## **Comments on the Applicant's Responses to the Examining Authority's Written Questions.**

Deadline for receipt of Comments to Responses: Friday 9<sup>th</sup> February 2024

Unique Reference Number: 20040614

Figure 1: Daytime noise levels from rail traffic, dB LAeq,16h

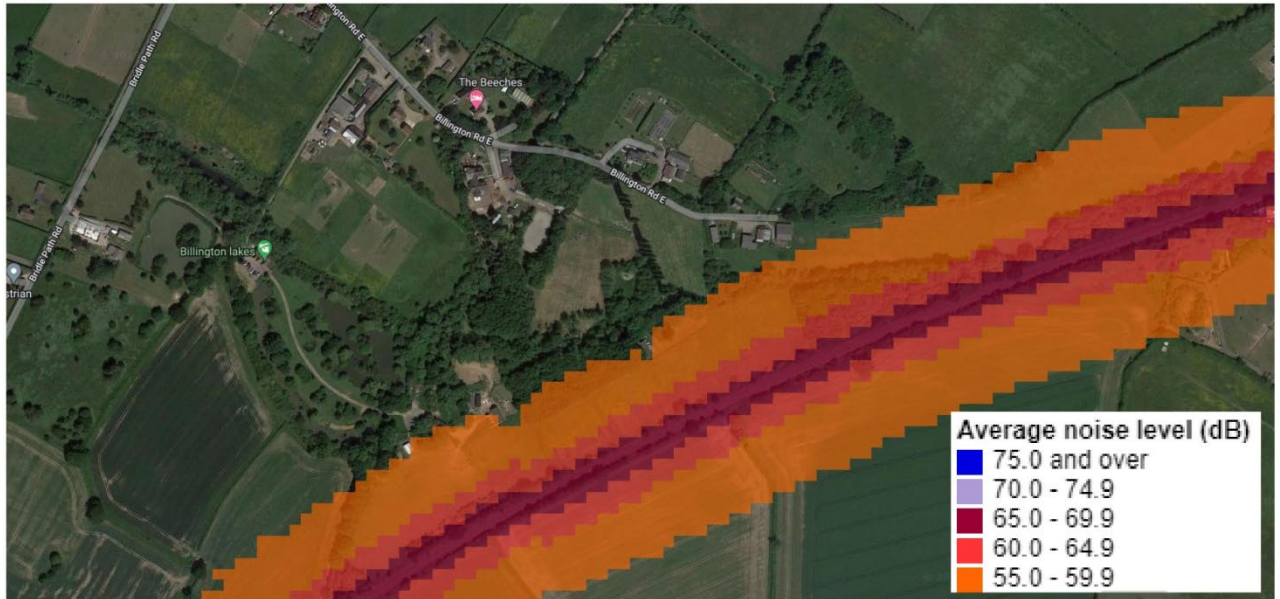
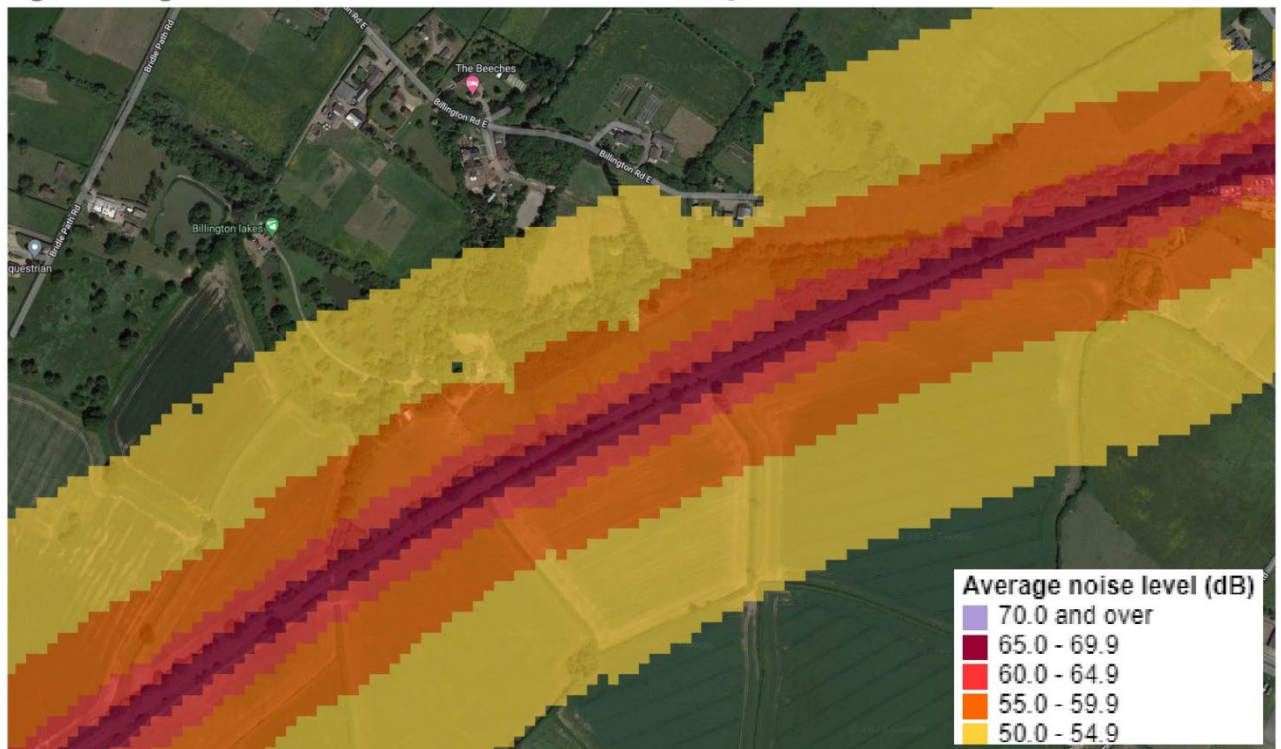
(In these two Figures you can clearly see the noise corridor, with its characteristic “bands” which are caused by the Attenuation with Distance from the railway that occurs as you move away from the rail line. As you move further from the rail line, you can see that the **rate** of this Attenuation with Distance progressively reduces such that each successive outward “band” is typically twice the width of the previous inner one.)

Now, this provides a very descriptive picture of the Attenuation Process that naturally occurs. But you begin to see warning signs when you compare the daytime noise contour “bands” shown in Figure 1 with those shown for the night-time in Figure 2. Although you would expect to see a considerable narrowing during the quieter night-time period, you can actually see no obvious change between the two. (For context here, NMP4 indicates a night-time noise reduction of 3dB compared with daytime, so we would expect to see the width of each of the bands (and therefore also the overall width of the noise corridor) to reduce by a factor of 2.)

Although I cannot actually show this level of detail here, I have gone onto the Extrium website and compared online the widths of the noise corridors (as bounded by the **orange** bands) in Figures 1 and 2 during daytime and night-time respectively. The night-time width is actually some 8% **greater**, and so indicates a **noise increase** at night-time. So we are clearly dealing with broad-brush data here.

But it’s when you actually come to look at the dB values in the Table Keys that the alarm bells really start to ring. For example, in Figure 2, the boundary between the orange and the yellow bands is indicated at 55.0dB. But this is almost the same night-time Noise level of 56.3dB that was measured at NMP4 at a location just 12 metres from the track!

Further analysis indicates that in comparison with the precise “Gold Standard” Noise measurements performed at NMP4 over a period of seven days, the data in Figures 1 and 2 overstates the Train Noise levels by approximately 12dB during the daytime, and rather more at night-time. So the values in the dB Keys in Tritax’s Figures 1 and 2 need to be adjusted downwards by 12dB accordingly.

Or, for a visual indication, this means that the width of each of the bands (and therefore the overall width of the noise corridors) shown in Tritax’s Figures 1 and 2 should be reduced by a factor of twelve. This, I believe, contracts the whole of the noise corridor banding shown in Figure 1 down to a narrow ribbon that is fully contained within the boundary of the railway property.

A yet further failing of the DEFRA Rail Data that Tritax seek to introduce in their Update Note is that it provides no information in respect of the much quieter periods of the weekends, and especially the weekend night-times, when very few, if any, trains run, and when the contours Tritax have shown will simply disappear because there is no Rail Noise at all.

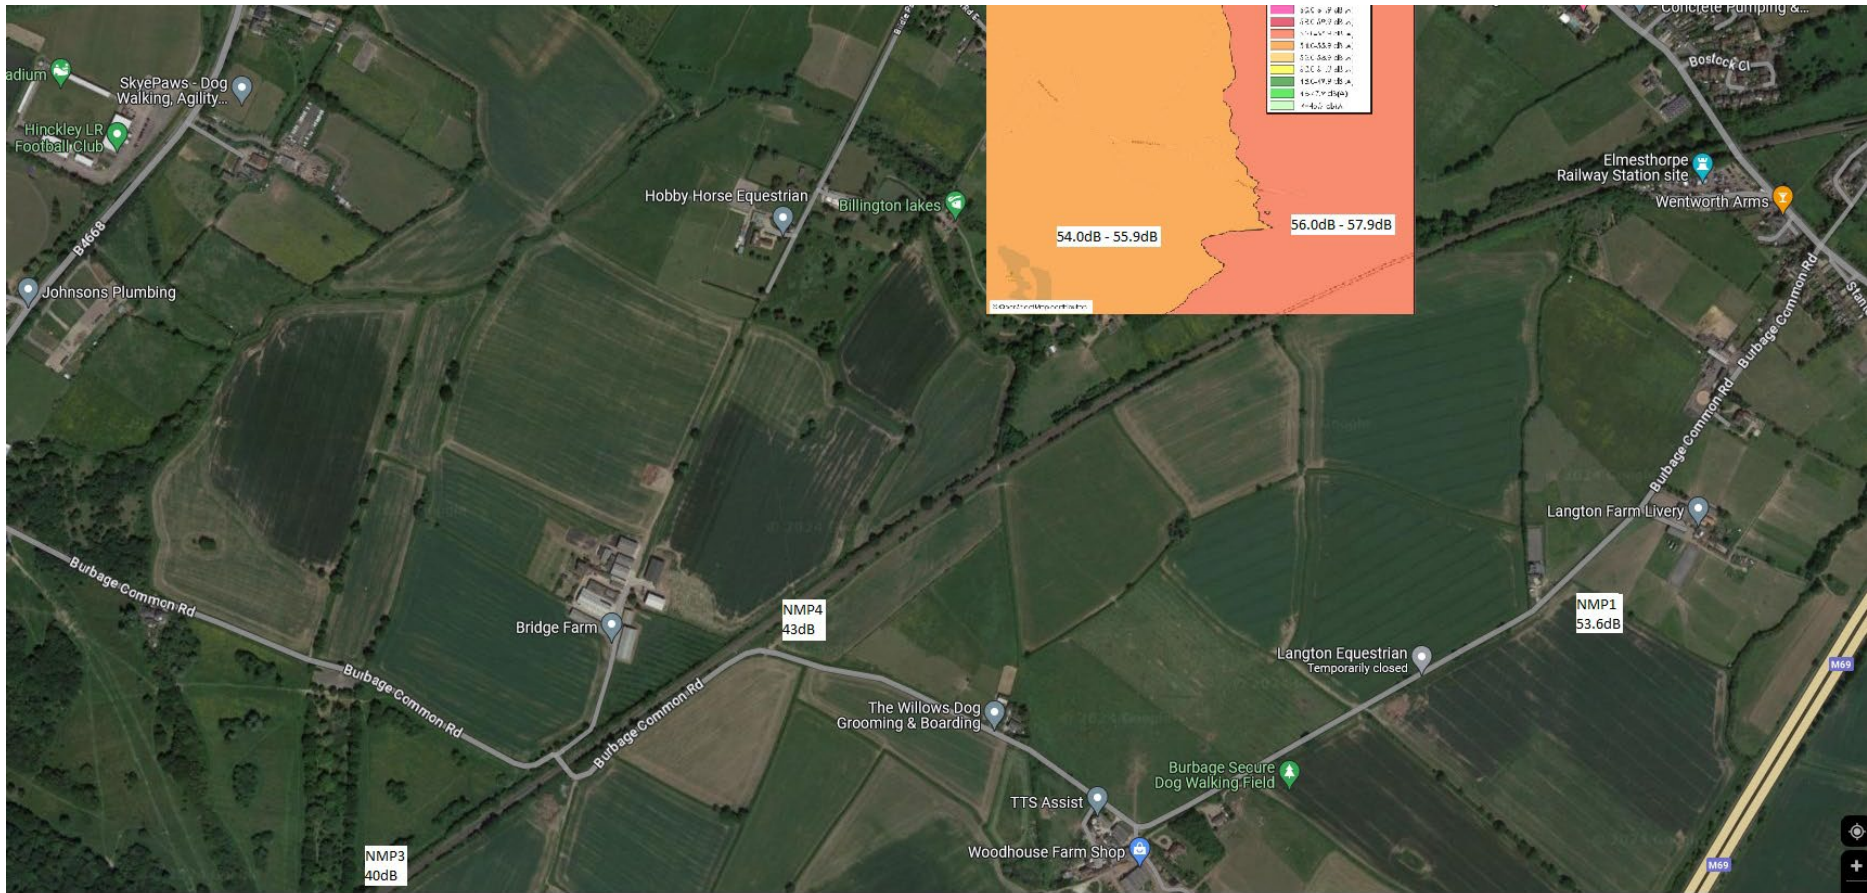
To make matters clearer here, I have prepared a mapping which shows NMP3, NMP4, and Tritax's Figure 3 all in the same Figure. This is shown below.

With reference to the Figure, we can see that the Road Noise levels at NMP3 and NMP4 are very similar to each other, differing by only 2dB or 3dB despite their distance apart. This is exactly as would be expected in view of their very considerable distance from both the M69 and the B4668, and the very “flat” noise profile this would bring about. And of course, Figure 3 also displays the same type of very “flat” noise profile, again owing to its distance from the M69 and the B4668.

But the big surprise comes when we compare the measured Ambient Road Noise levels at NMP3 and NMP4 with Tritax’s predicted Road Noise levels in Figure 3. Here we find that there is a major disjoint of 12dB between the measured Road Noise value at NMP4 (at between 41dB and 44dB) and Tritax’s predicted Road Noise values (at between 54dB and 55.9dB). And, even more surprising is that this occurs over a very moderate distance and in the very “flat” noise environment determined by the M69 and the B4668 that are both over a kilometre away!

In the case of NMP1, the Ambient Noise level of 53.6dB **includes** the Train Pass Bys (there being no way of removing the Rail Noise from the data made available by Tritax). And of course it also **includes** the local roadside noise on Burbage Common Road. So the Ambient Noise level of 53.6dB indicated at NMP1 in my Figure will be **rather higher than the Actual Road Noise in the surrounding area.**

With reference to the Figure, you may see that the measured Noise Level at NMP1, which is rather higher than the Actual Road Noise in the surrounding area, is in fact 3.4dB **lower** than Tritax’s predicted Road Noise (of between 56dB and 57.9dB) shown in their Figure 3, **despite the fact that NMP1 is only a third of the distance away from the dominating M69!**

In view of the all of the above, Tritax’s predicted Ambient Noise Levels indicated in their Figures 3 and 4 require further investigation. When compared with the “Gold Standard” noise measurements at NMP3, NMP4, and NMP1, and taking into consideration the flat local noise profile, they appear inexplicable.
